16-24 Kennedy Street: Partition and door sound insulation mark-ups

Kennedy Street Properties

Proposed - Basement Plans

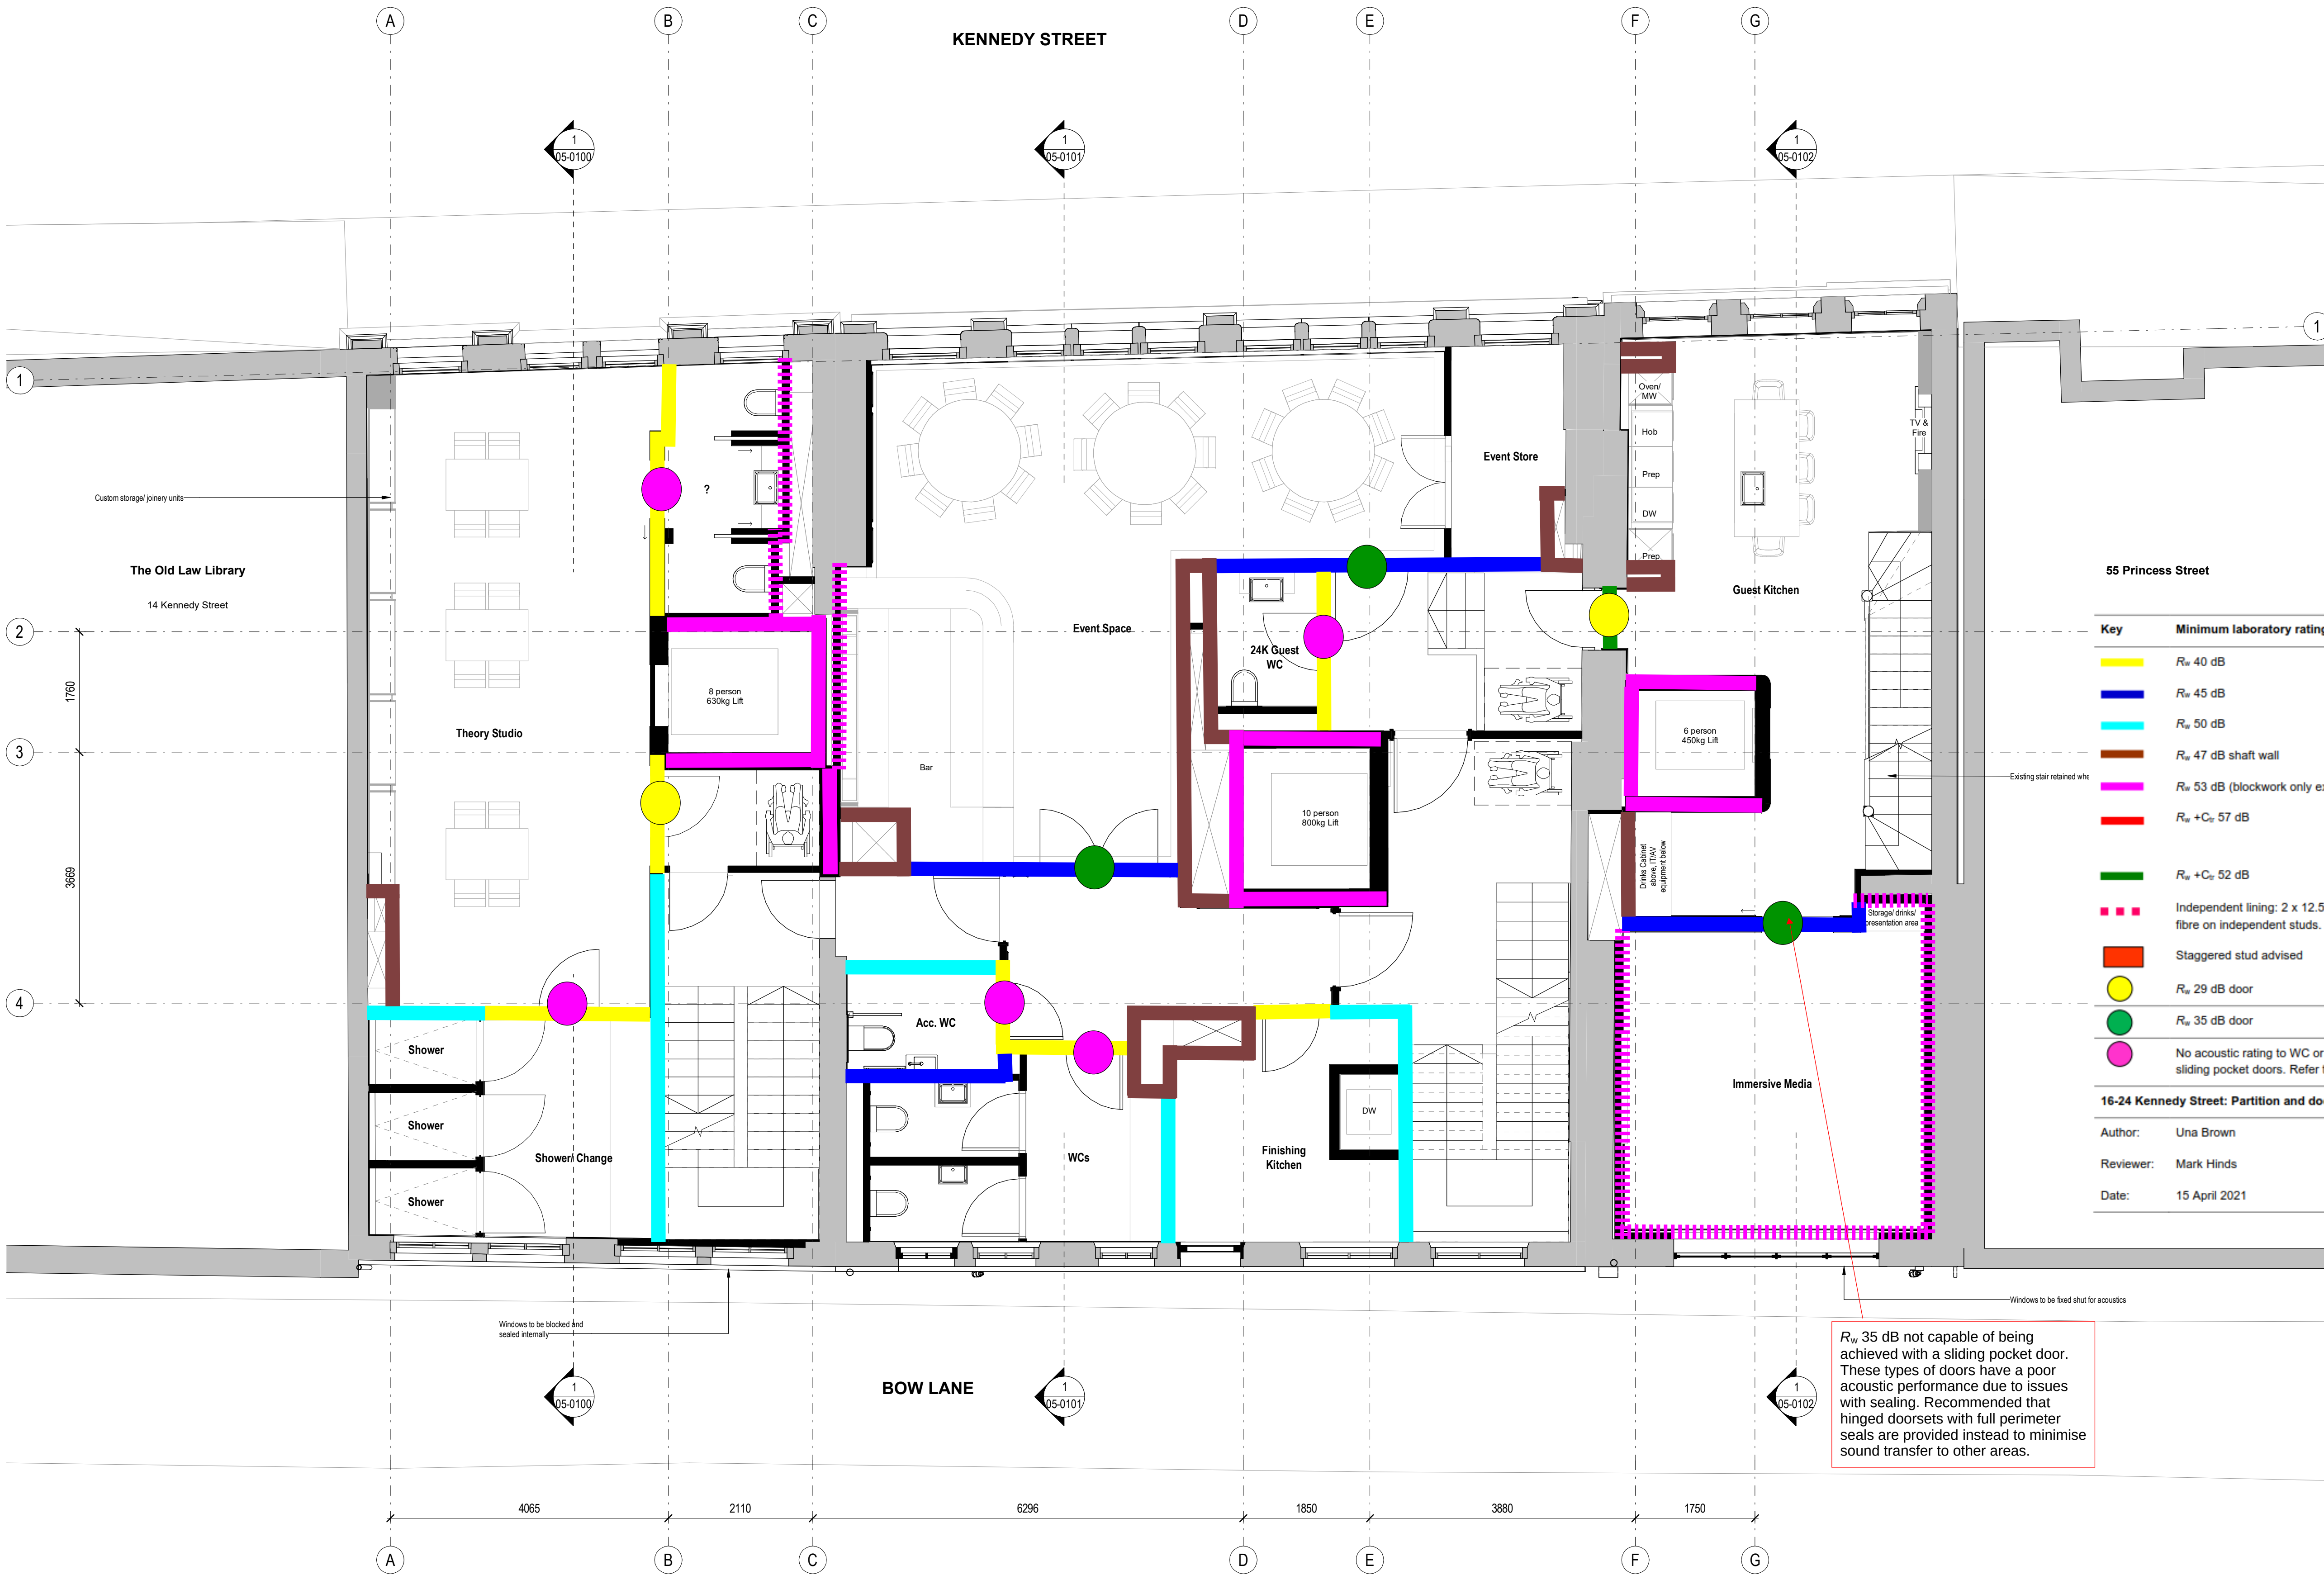
Key	Minimum laboratory rating	Minimum on-site performance
	R_w 40 dB	-
	R_w 45 dB	-
	R_w 50 dB	-
	R_w 47 dB shaft wall	-
	R_w 53 dB (blockwork only excludes linings)	-
	$R_w + C_w$ 57 dB	$D_{nt,w} + C_w$ 43 dB (minimum for ADE) $D_{nt,w} + C_w$ 48 dB (target)
	$R_w + C_w$ 52 dB	$D_{nt,w} + C_w$ 43 dB (ADE room front)
	Independent lining: 2 x 12.5 mm dense plasterboard (≥ 25 kg/m ²) with 25 mm mineral fibre on independent studs.	
	Staggered stud advised	
	R_w 29 dB door	
	R_w 35 dB door	
	No acoustic rating to WC or kitchen doors where they are undercut for ventilation or sliding pocket doors. Refer to main text in document.

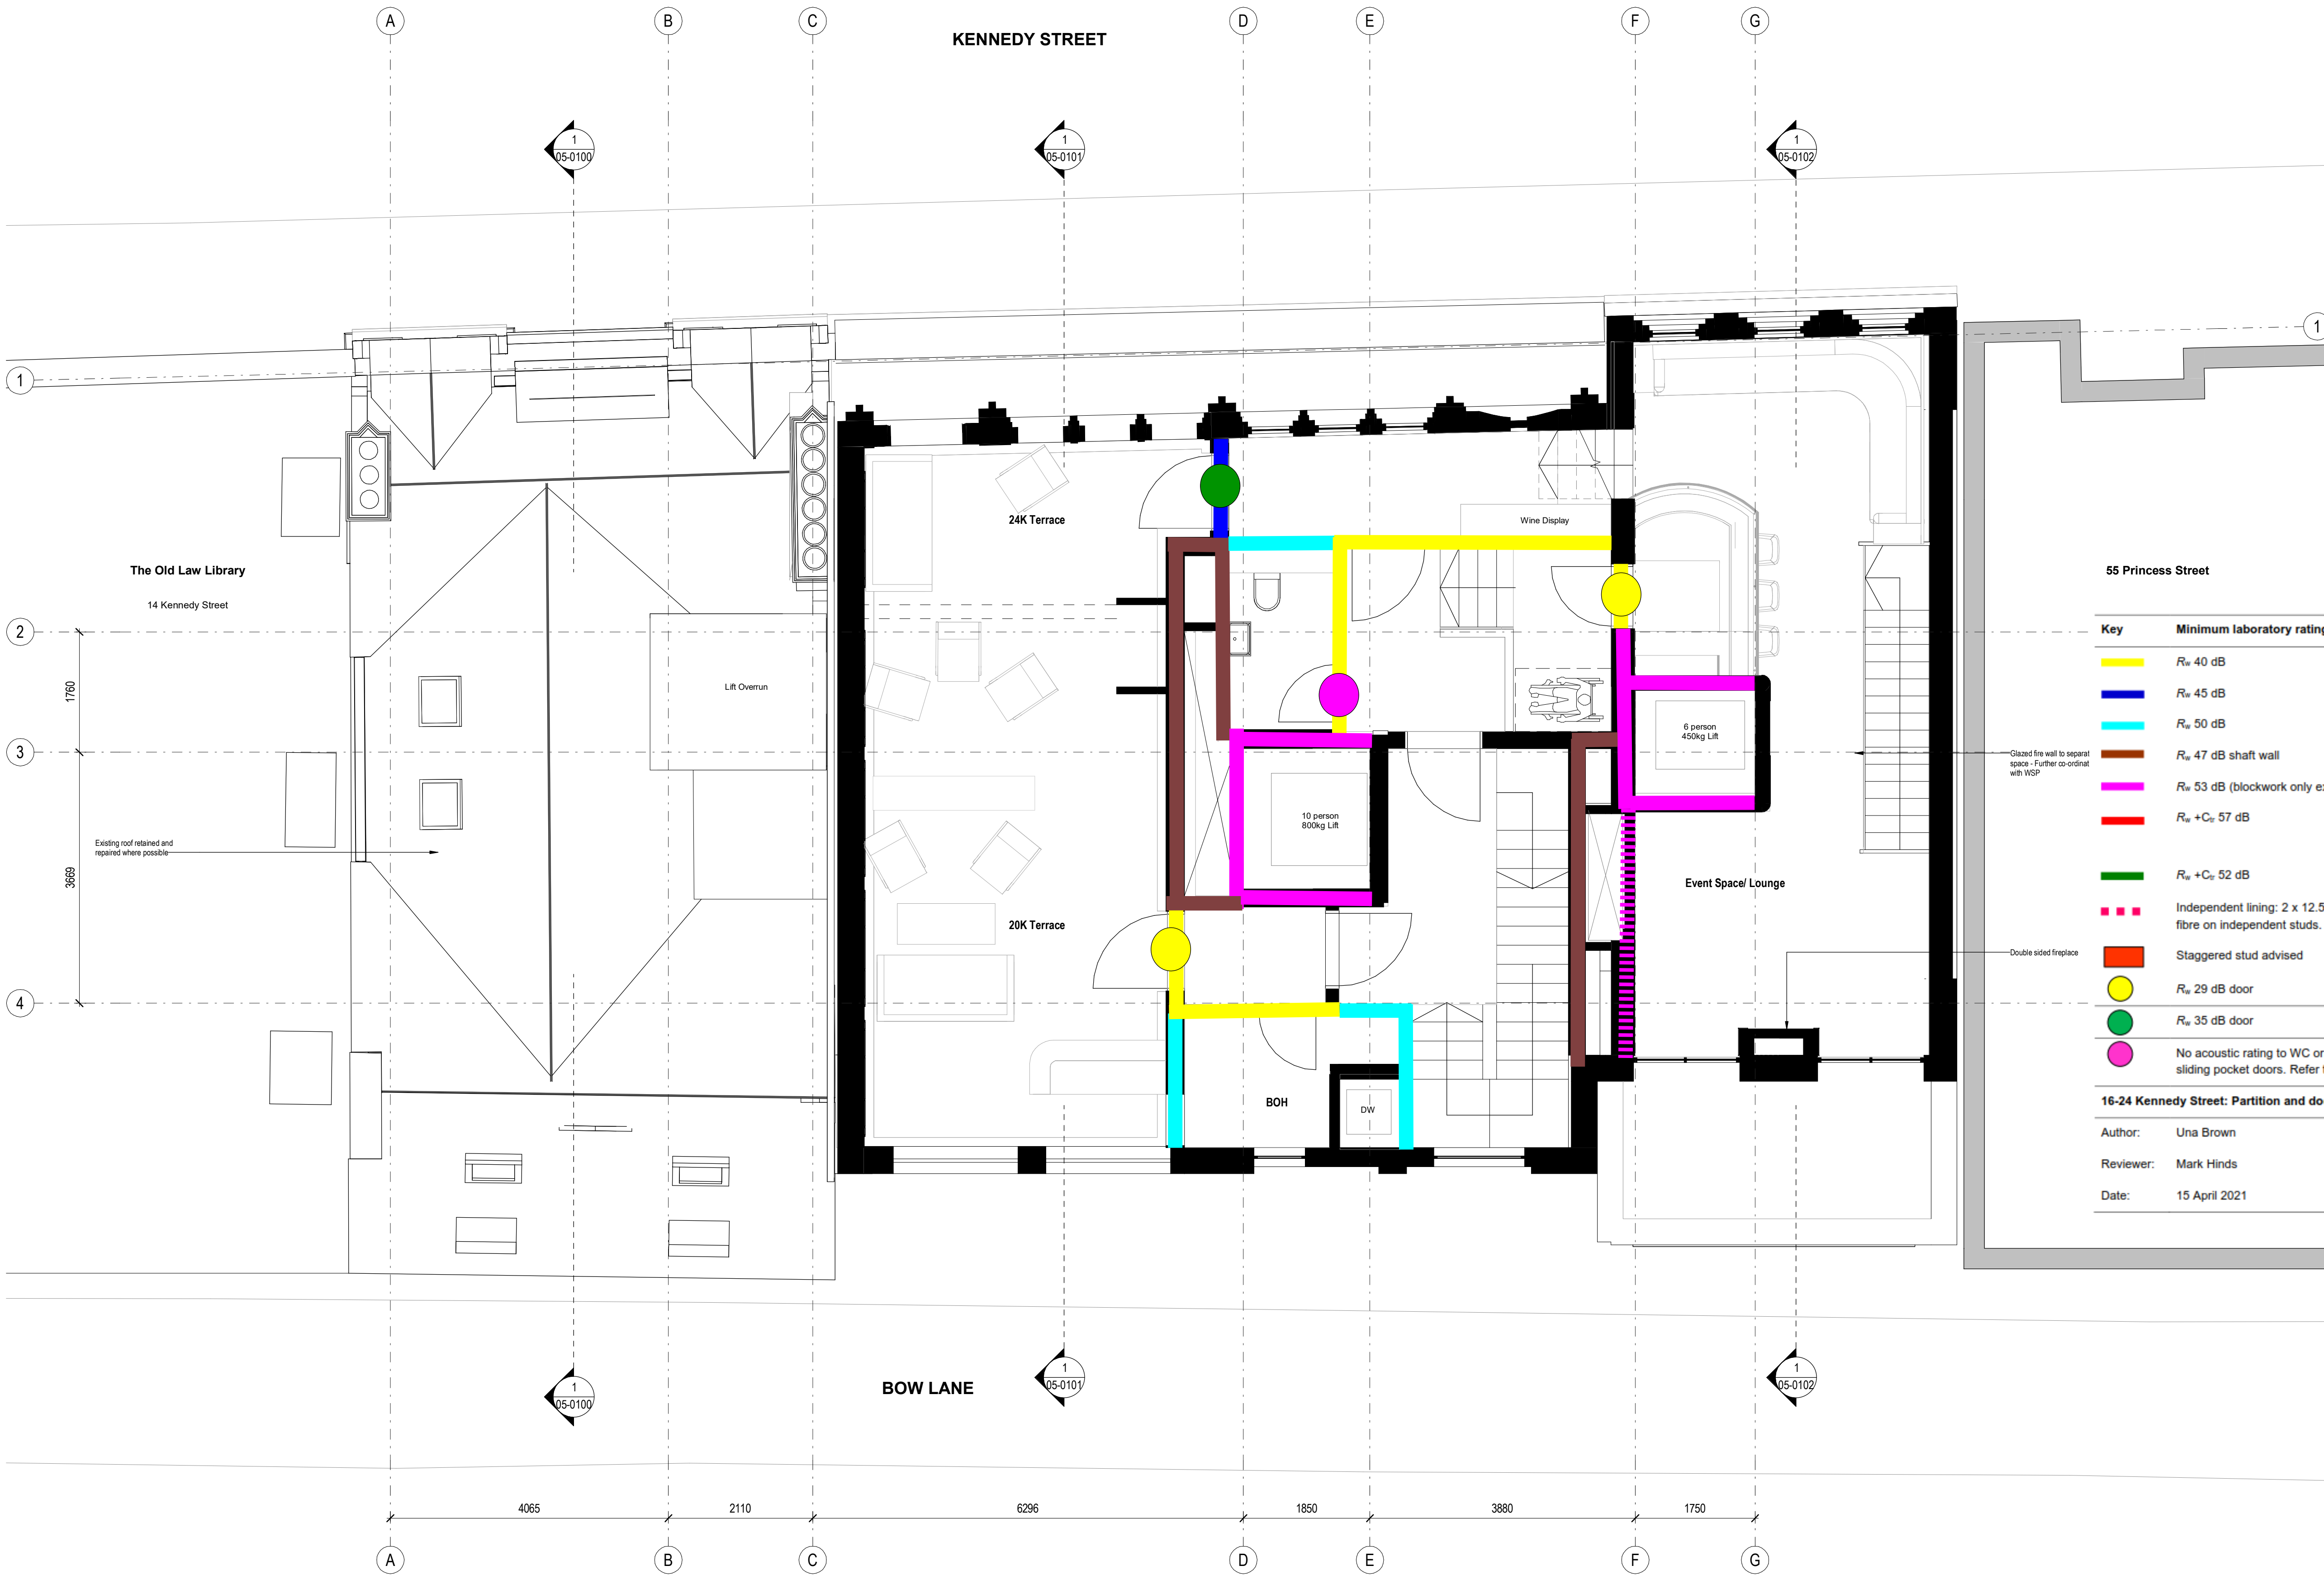
Key	Minimum laboratory rating	Minimum on-site performance
	R_w 40 dB	-
	R_w 45 dB	-
	R_w 50 dB	-
	R_w 47 dB shaft wall	-
	R_w 53 dB (blockwork only excludes linings)	-
	$R_w + C_{tr}$ 57 dB	$D_{nT,w} + C_{tr}$ 43 dB (minimum for ADE) $D_{nT,w} + C_{tr}$ 48 dB (target)
	$R_w + C_{tr}$ 52 dB	$D_{nT,w} + C_{tr}$ 43 dB (ADE room front)
	Independent lining: 2 x 12.5 mm dense plasterboard (≥ 25 kg/m ²) with 25 mm mineral fibre on independent studs.	
	Staggered stud advised	
	R_w 29 dB door	
	R_w 35 dB door	
	No acoustic rating to WC or kitchen doors where they are undercut for ventilation or sliding pocket doors. Refer to main text in document.	
16-24 Kennedy Street: Partition and door sound insulation mark-ups		
Author:	Una Brown	
Reviewer:	Mark Hinds	
Date:	15 April 2021
